Town of Hilton Head Island Regular Design Review Board Meeting

July 12, 2016

AGENDA

SHEET TITLE
SERVICE AREA
PLANTERS PLAN
& REAR ELEVATION

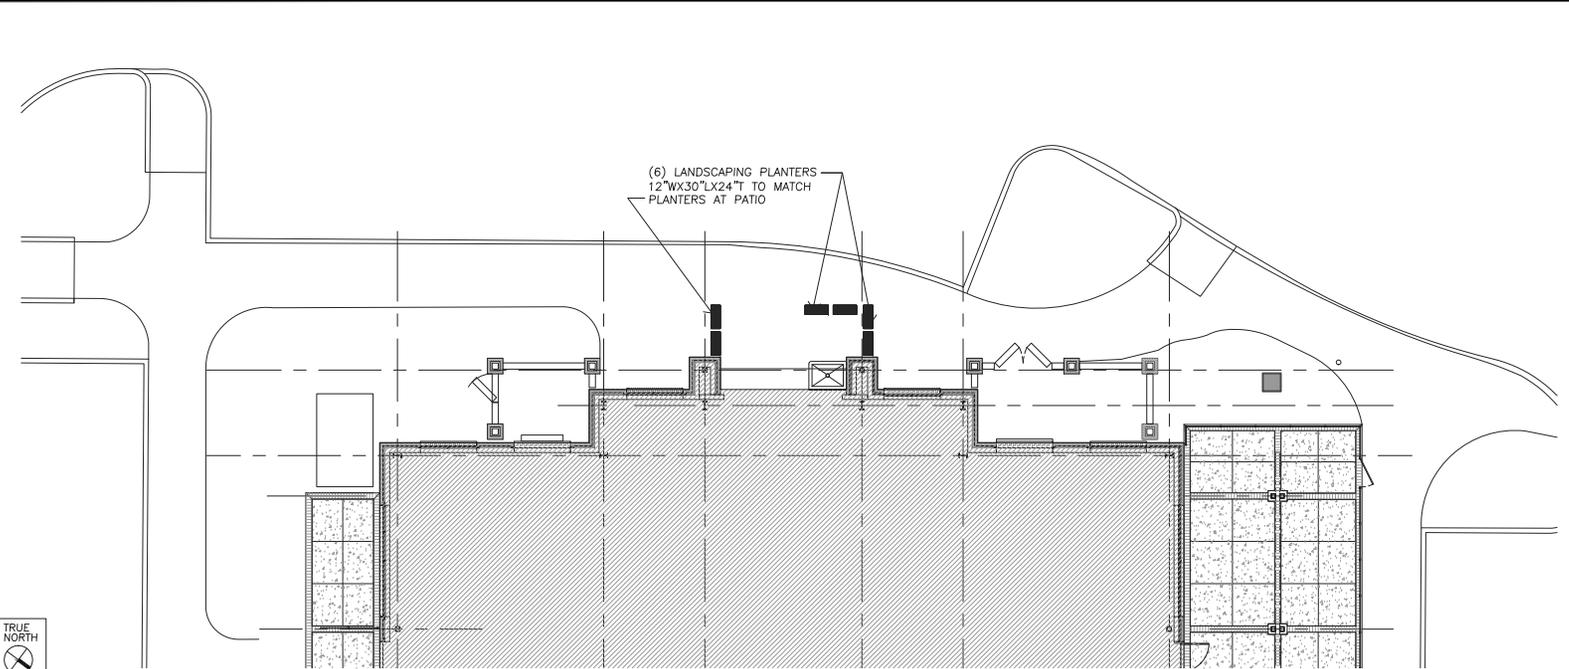
1. Specify / select tall evergreen plants for the planters to screen and coordinate with the existing planting on the site.
